APPLICATION FOR PERMISSION UNDER SECTION 16 OF THE TOWN PLANNING ORDINANCE (CAP.131)

For Official Use Only 請勿填寫此欄	Application No. 申請編號	A / N7-F7A / 201
	Date Received 收到日期	18 DEC 2020

Hong Kong Chilled Meat & Poultry Association 香港冰鮮家禽業商會

PlanPlus Consultancy Limited

Figure 3.4: Mitigation Measures for on-site Vehicle Movement

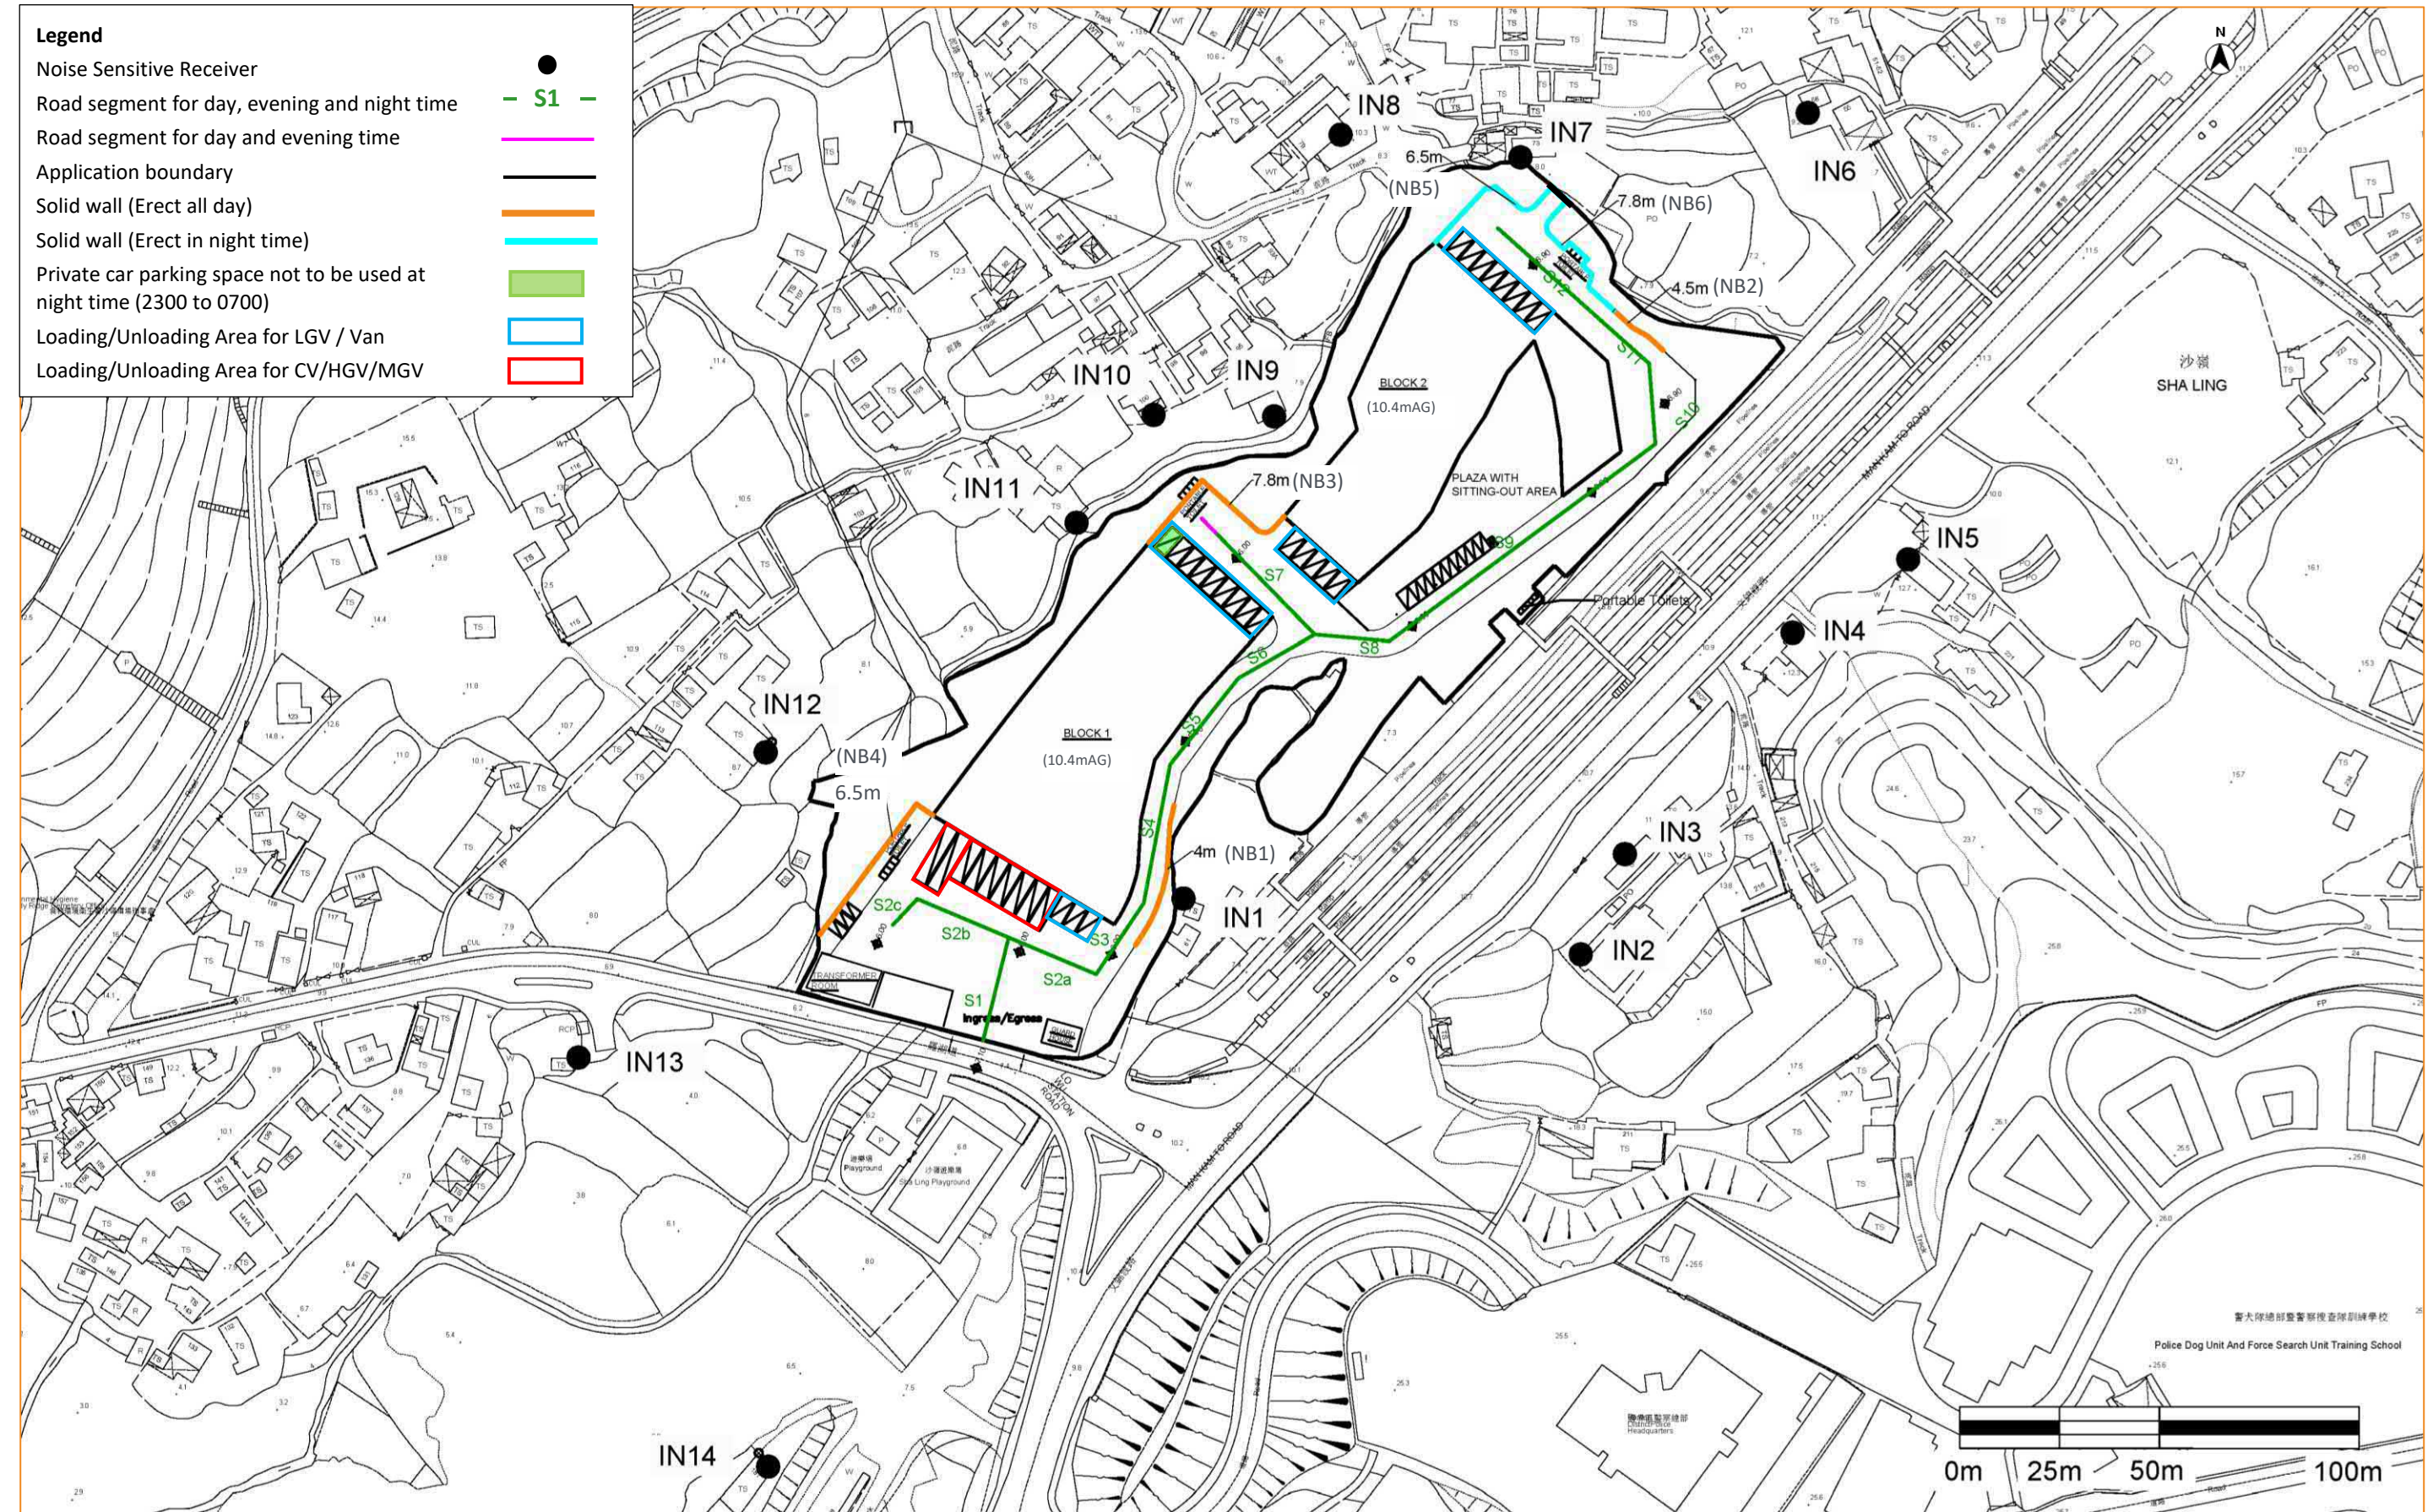
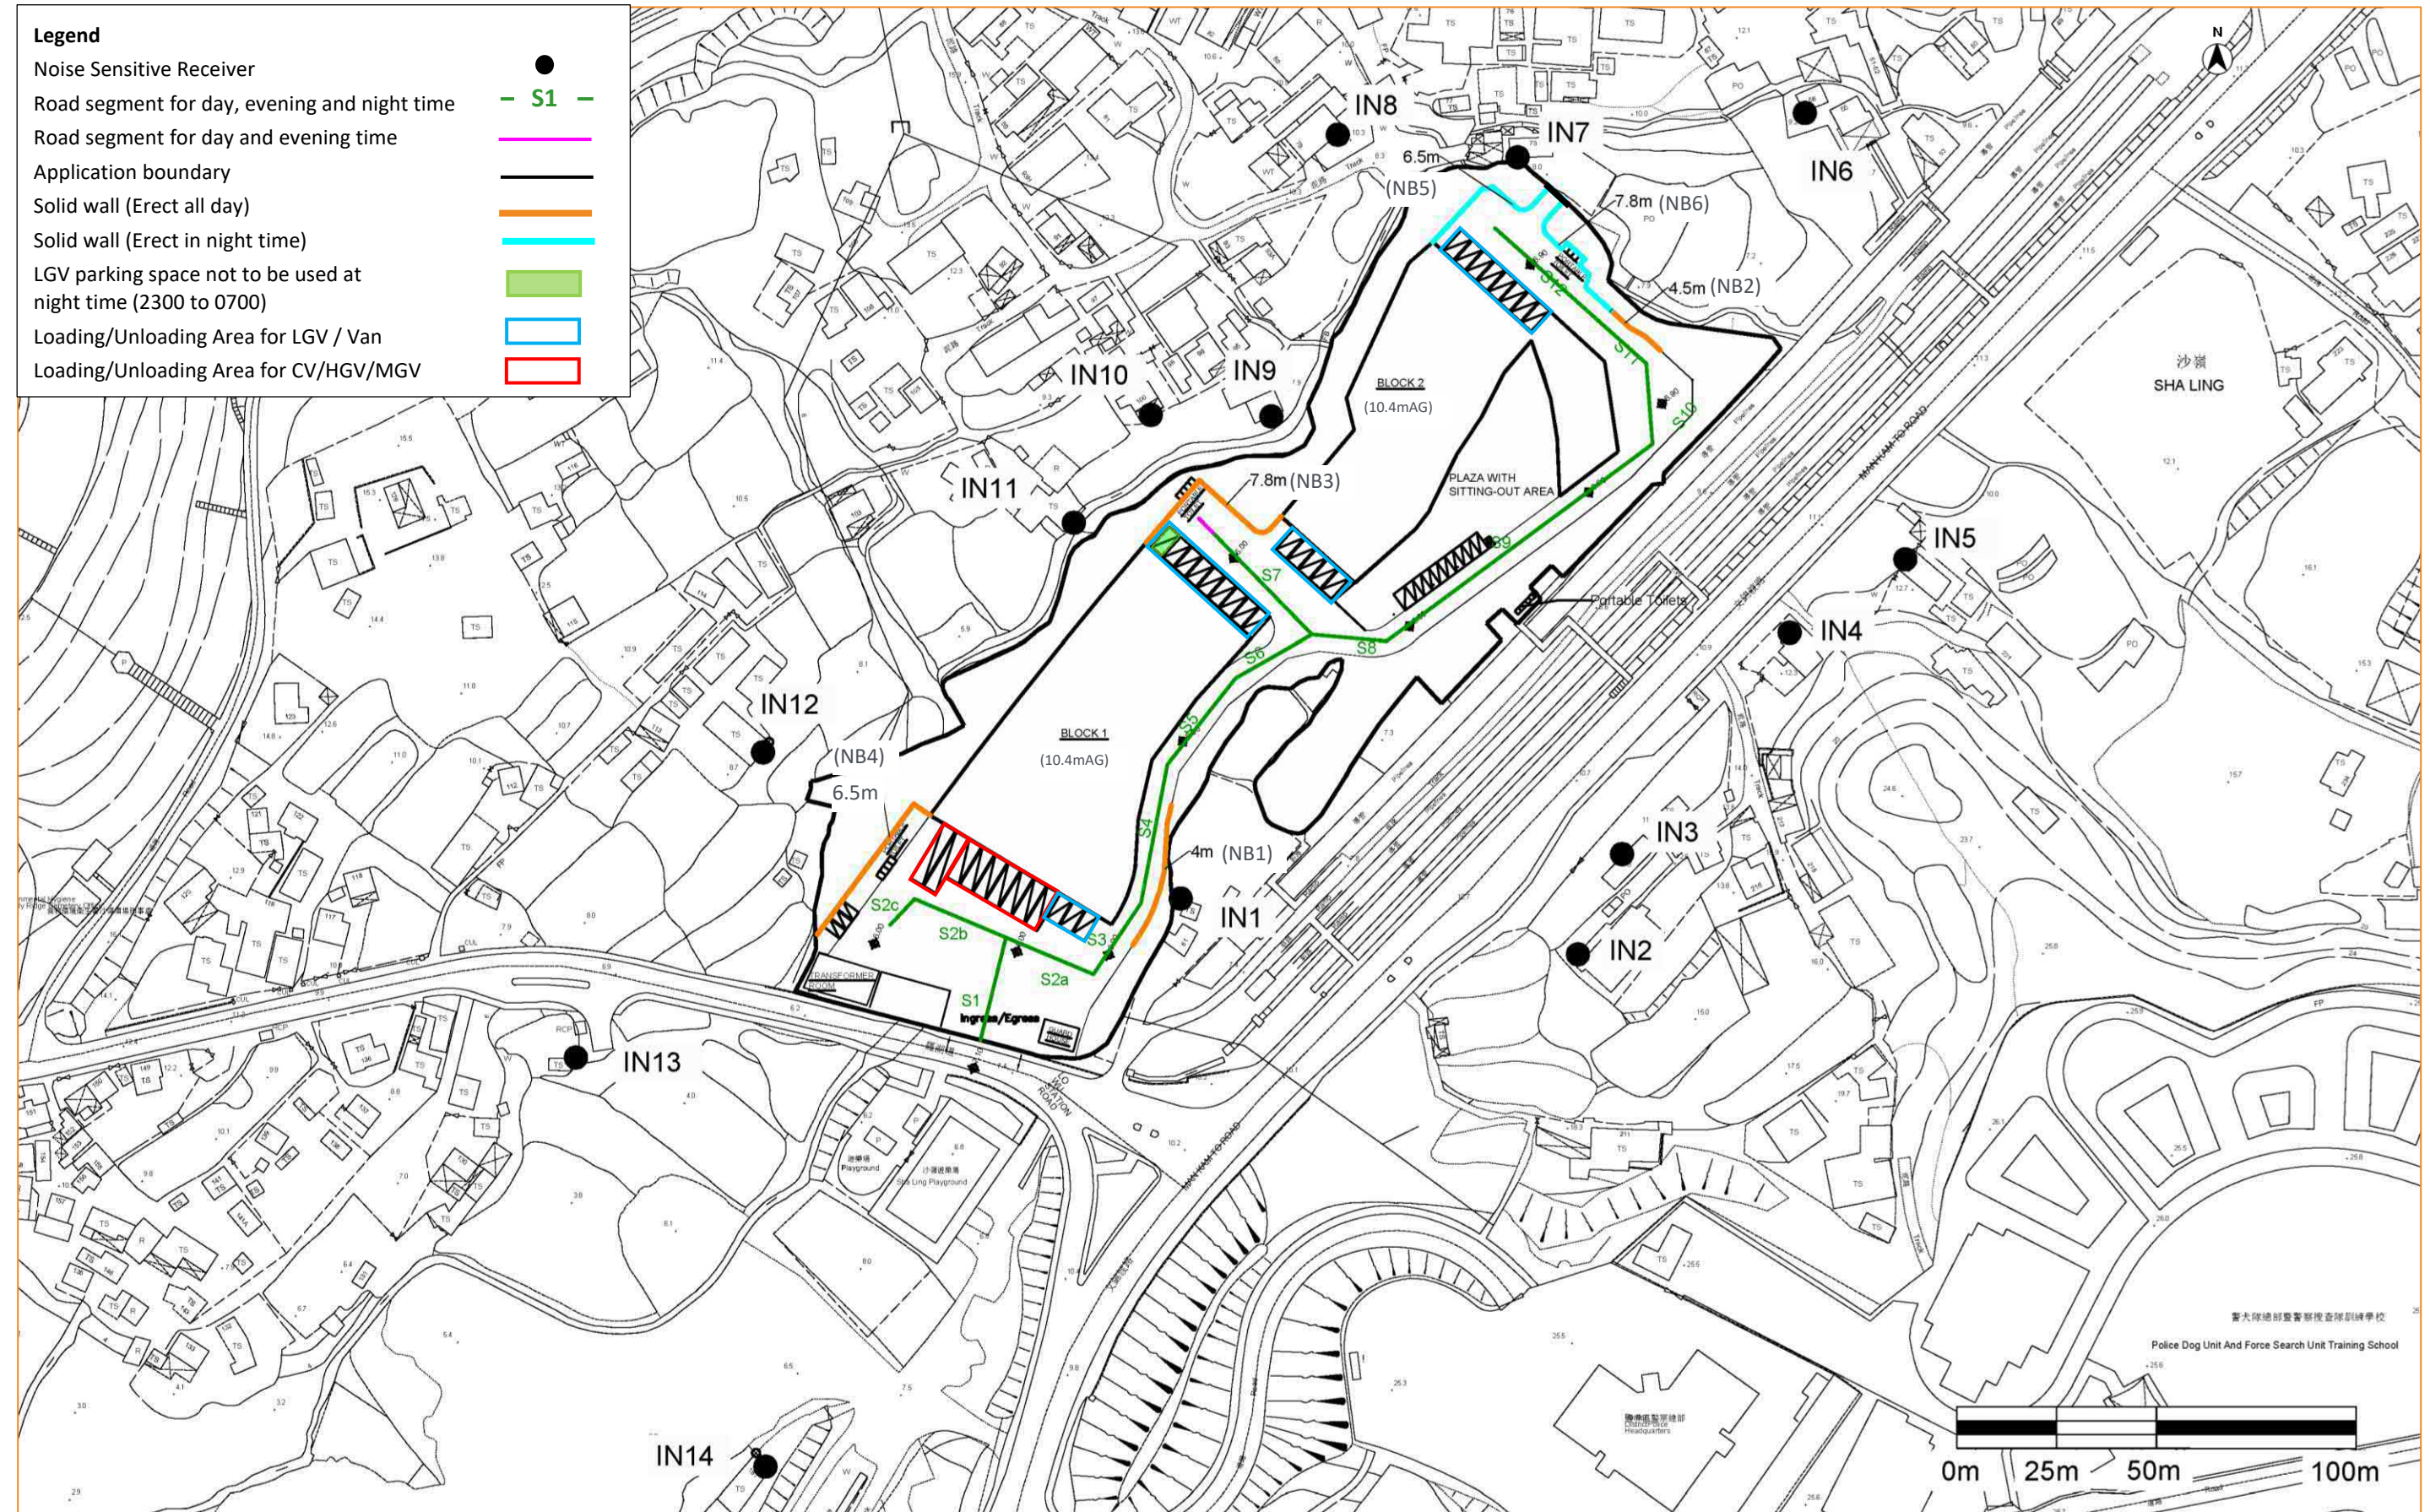
<p>21.Sections 3.3.30, 3.3.36 and Figure 3.4:</p> <p>I. We noted that 2.5m metal mesh are proposed along the site boundary, while isolated solid walls ranging from 3.5m to 6.6m in height are proposed near the vehicle maneuvering path within the application site. As the proposed establishment is a noise emitter which would give noise nuisance to nearby NSRs, mitigation measures under (i) s.4.2.14 and s.4.2.15 of HKPSG Chapter 9, and (ii) ‘Code of Practice on Handling the Environmental Aspects of Temporary Uses and Open Storage Sites’ shall be followed in designing the proposed establishment, in particular on provision of screening structures to the noise sources on-site (e.g. maneuvering of vehicles on site, reverse movements). As shown in Figure 3.4, despite solid walls are provided, most of the NSRs still have direct line of sight to the vehicle maneuvering path within the application site.</p>	<p>The extent and height of solid wall have been revised that:</p> <p>(a) Sections 3.3.37 to 3.3.40 and 3.3.49 have been revised to summarise the mitigation measures for noise impact.</p> <p>(b) Figures 3.4 and 3.5 have been revised to show the indicative location of the proposed noise mitigation measures.</p>

10. The applicant should review inconsistencies in description of noise barriers in Section 3.3.37 – 3.3.38 of the EA, Table 6.1 and Figure 3.4. For clarity, please consider providing ID no. for the noise barriers in the main text and the relevant figure.	Section 3.3.37 – 3.3.38, Table 6.1 and Figure 3.4 has been revised, and ID numbers have been provided as follows: <ul style="list-style-type: none"> • NB1: A 4m barrier along road side of the south of the Site • NB2: A 4.5m barrier road side of northeast of the Site • NB3: A 7.8m barrier along the road side of northwest of the Site • NB4: A 6.5m barrier along road side of northwest of the Site • NB5: A 6.5m barrier next to the segment 12 at night time (2300 to

Date	Department	Comments	Responses
		<u>Environmental Assessment</u>	
		<ul style="list-style-type: none"> - Para. 3.3.16: Please update the no. of L/UL platforms. - Figure 3.4: (i) The L/UL bay not to be used at night time (2300-0700) should be a L/UL bay for LGV. Please amend. (ii) The NB4 of 6.5 m high near the transformer room should be accurately reflected on the MLP. - Figure 3.5: The proposed 2 m high barriers on top of Blocks 1 and 2 should be shown on MLP. 	<ul style="list-style-type: none"> - Para. 3.3.16: The sentence "The mitigation measures will be applied to all 5 loading/unloading platforms" has been amended to "The mitigation measures will be applied to all loading/unloading platforms" which "5" has been deleted from para. 3.3.16. - Figure 3.4: <ul style="list-style-type: none"> (i) Noted and revised accordingly. (ii) Noted and revised accordingly. - Figure 3.5: Noted and revised accordingly.

- 3.3.38 As the proposed development will be operated around the clock, the on-site vehicle movement during night time may cause adverse noise impact on the nearby village with a quiet environment. Therefore, it is proposed to construct a 6.5m (i.e. NB5) and a 7.8m (i.e. NB6) high solid wall (minimum surface density of 10kg/m²) at the north boundary of the Site next to segment 12 for NSR IN7. The barrier will be erected before the start of night time (2300 to 0700), also the LGV parking space next to segment 7 would not be used at night time (2300 to 0700), as shown on **Figure 3.4**, to minimise the potential noise impact.

- 3.3.49 A 2m height barrier is proposed on the top of north-west of Block 1 (i.e. NB7) and north-east of Block 2 (i.e. NB8) to reduce the direct line-of-sight of NSR IN12 and NSR IN7 respectively, as shown on **Figure 3.4** and **Figure 3.5**.
